From: Wayne Gander <wayne@wgander.freeserve.co.uk>
Sent: 15 January 2013 18:07
To: Hannah Barker
Cc: coombesdaryl@gmail.com
Subject: 79 Upper Brighton Road
Attachments: Proposals 02A.pdf; Proposals 03A.pdf

79 UPPER BRIGHTON ROAD, LANCING
Proposals 02 A Dec 2012

Proposals 03 A Dec 2012

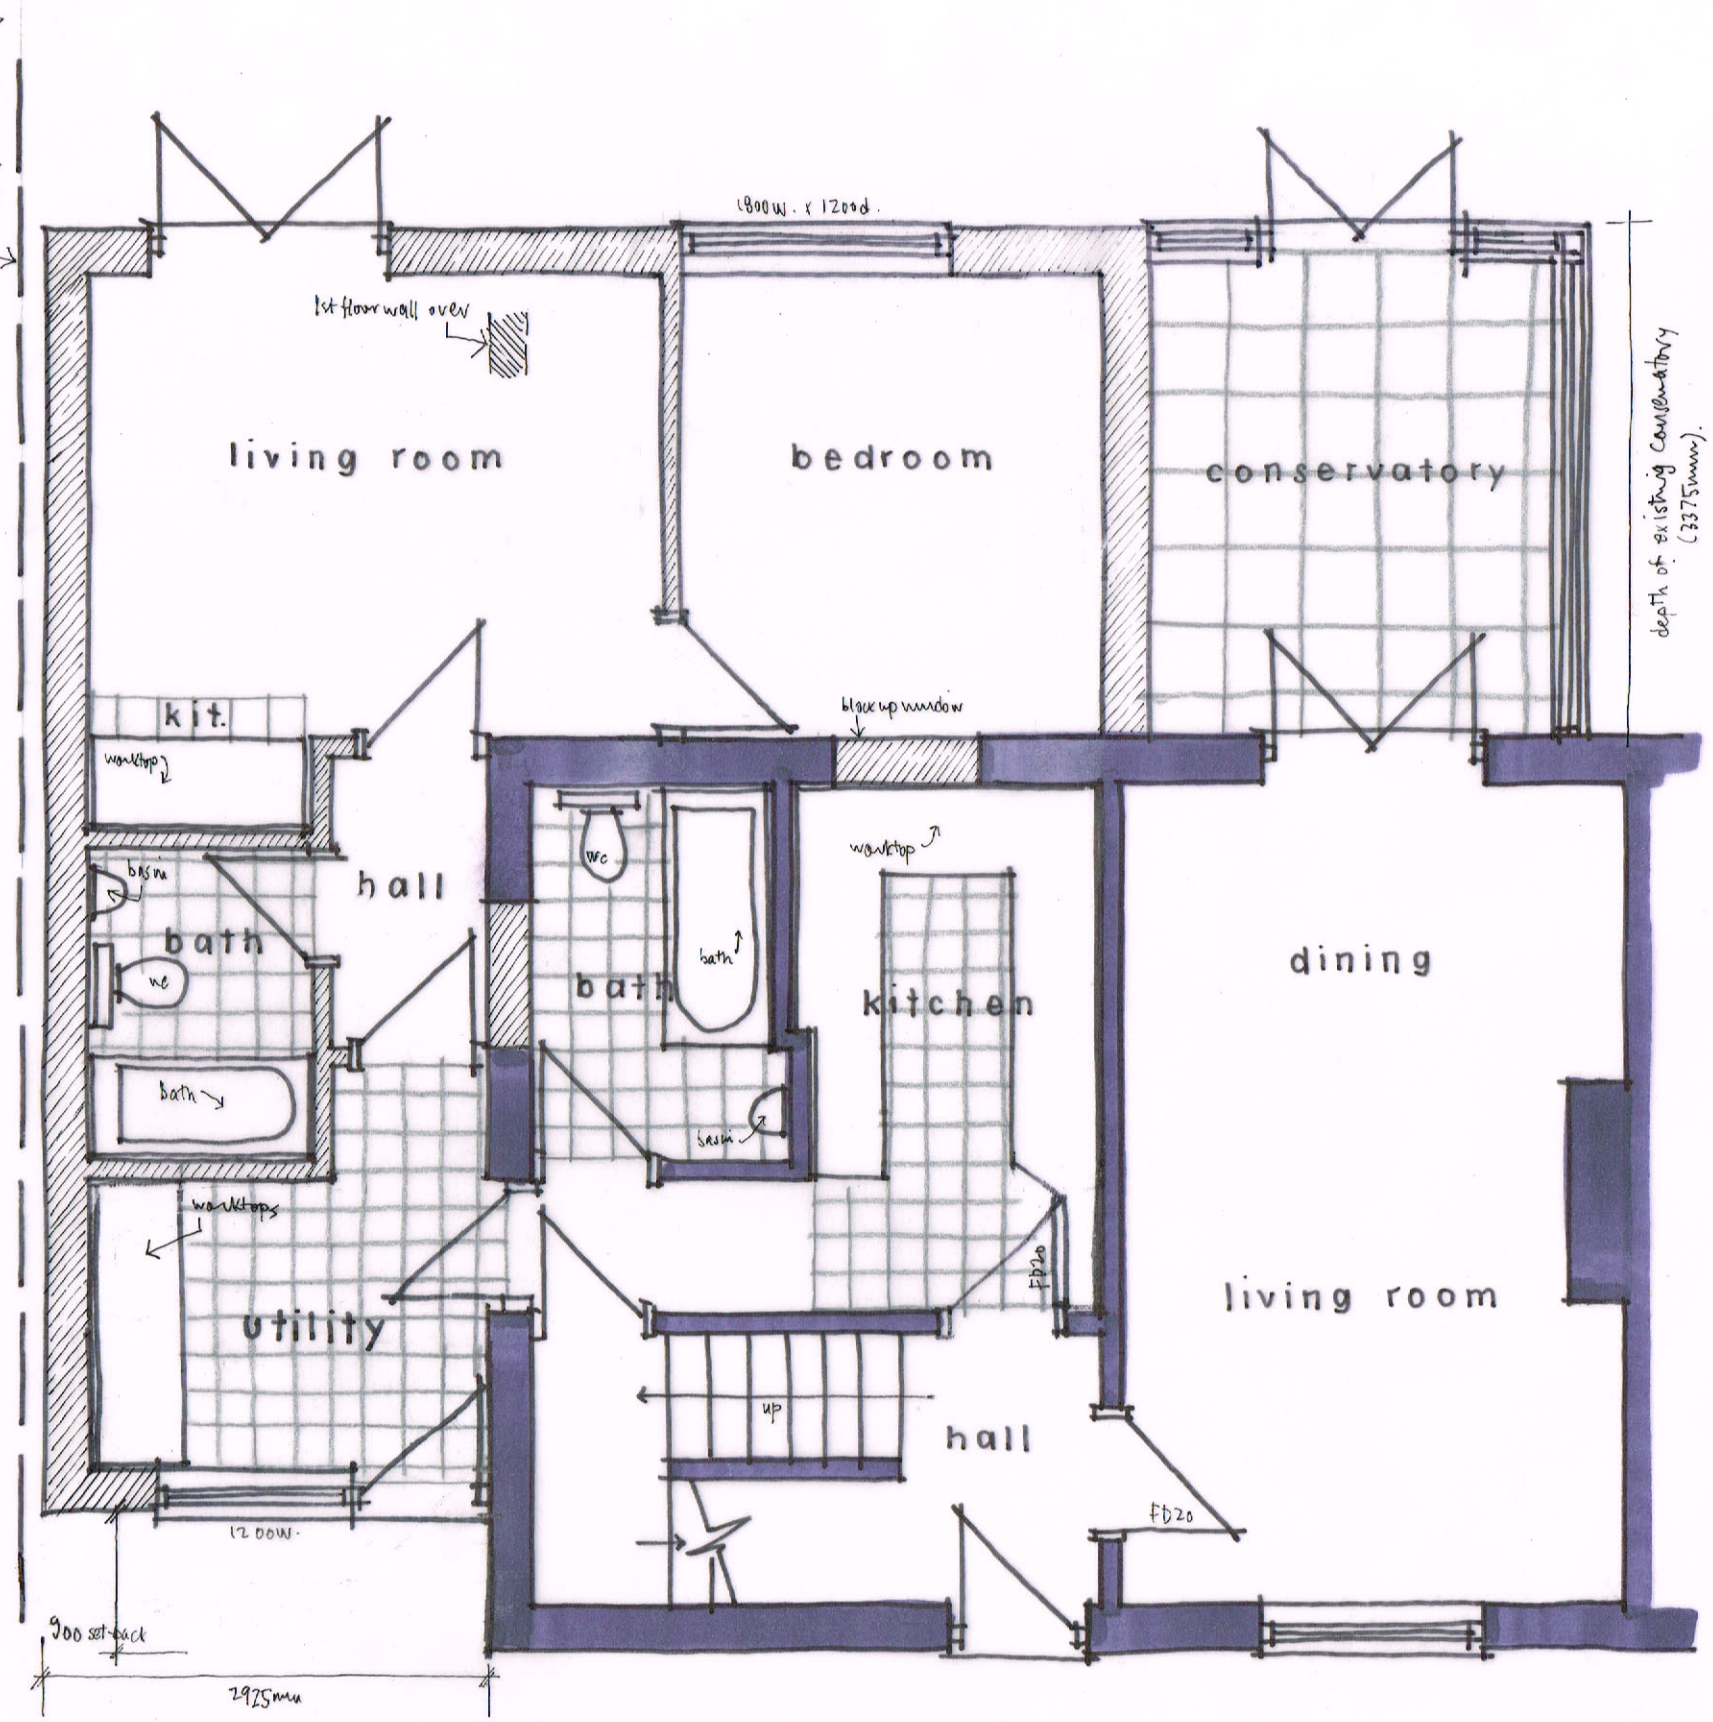
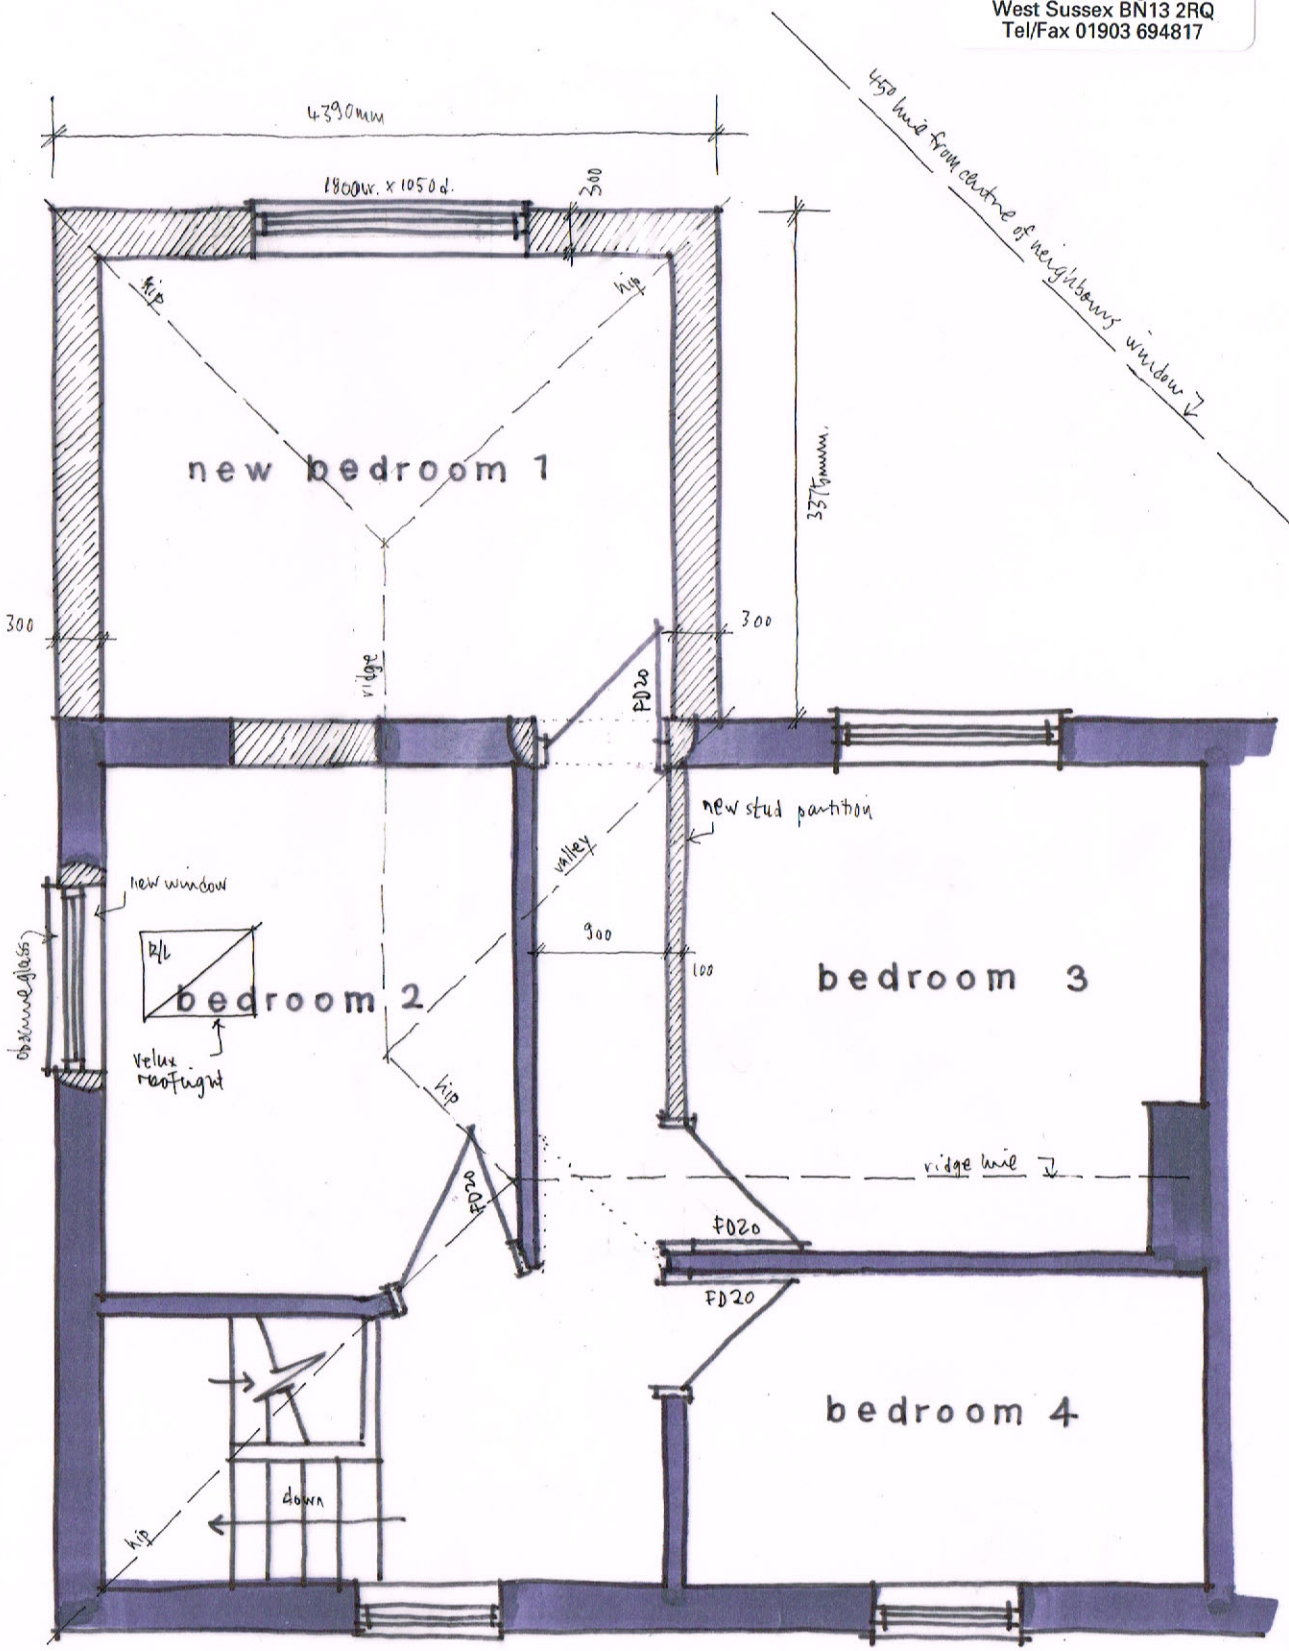
I have now received payment and the application is now valid. We can validate the application and start the process. However following my preassessment I can advise that the proposed side window at first floor will result in unacceptable overlooking to the rear of the adjacent dwelling to the east, it will overlook both the dwelling house and garden. This is considered to be unacceptable. However if the window was to be obscurely glazed with a fanlight only this would provide a very poor level of accommodation which would be considered to be unacceptable for a bedroom. Also as you stated there may also be implications for building regulations.

Whilst, writing can I also request that there is more of a set back to the side extension. This could be achieved by removing the separate W.C.

Dear Hannah,
I have spoken to the applicant and building control and can confirm the following;
1. We are agreeable to the 1st floor side window being obscure glass and fixed shut up to 1.7m. Building control require each 1st floor bedroom to have a means of escape window which this will now not be, however instead if we create a protected staircase arrangement with the existing doors being replaced with fire doors we do not need the escape window. We have included an additional velux rooflight to that room.
2. We are willing to increase the setback at the front to 900m from the corner of the house.
I attach amended drawings showing these points and hope everything meets with your approval.
Regards.
Wayne

Revisions A - 900mm setback introduced, velux rooflight added 15/1/13
